UNITED STATES PATENT AND TRADEMARK OFFICE

APPLICATION NO.	FILING DATE	FIRST NAMED INVENTOR	ATTORNEY DOCKET NO.	CONFIRMATION NO.
09/960,086	09/20/2001	Rajiv Doshi	19441-0034	5046
7590	08/10/2004		EXAMINER	
Daniel J Warren Sutherland Asbill & Brennan LLP 999 Peachtree Street N E Atlanta, GA 30309-3996			CHANEY, CAROL DIANE	
			ART UNIT	PAPER NUMBER
			1745

Office Action Summary	Application No.	Applicant(s)	
	09/960,086	DOSHI ET AL.	
	Examiner	Art Unit	
	Carol Chaney	1745

Fig.1

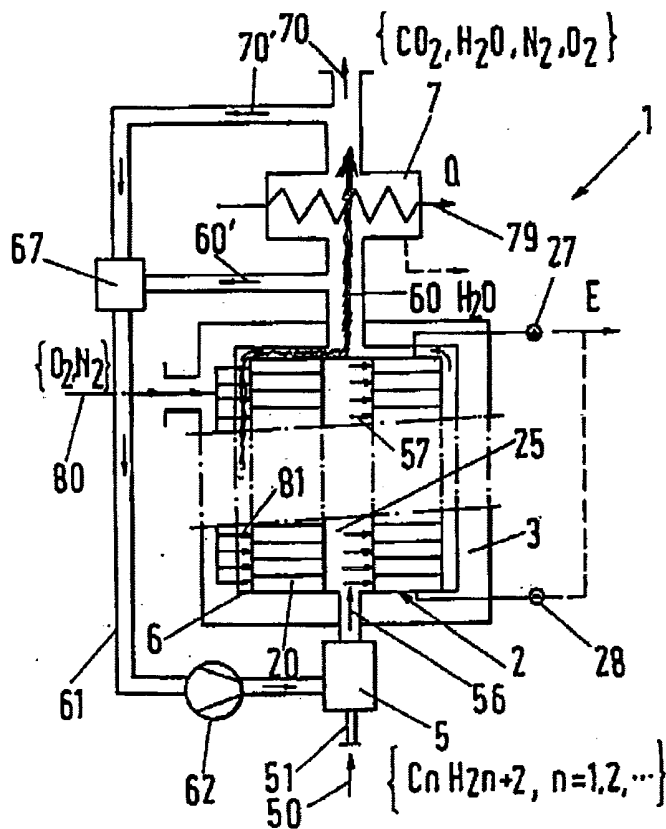
Applicants assert Schuler shows no fluid delivered from the "second interior cavity 6". However, as shown in Fig. 1 of the Schuler patent, fluid is clearly delivered from second interior cavity. The cavity could not accept an input of fluid without a fluid flow from the cavity.
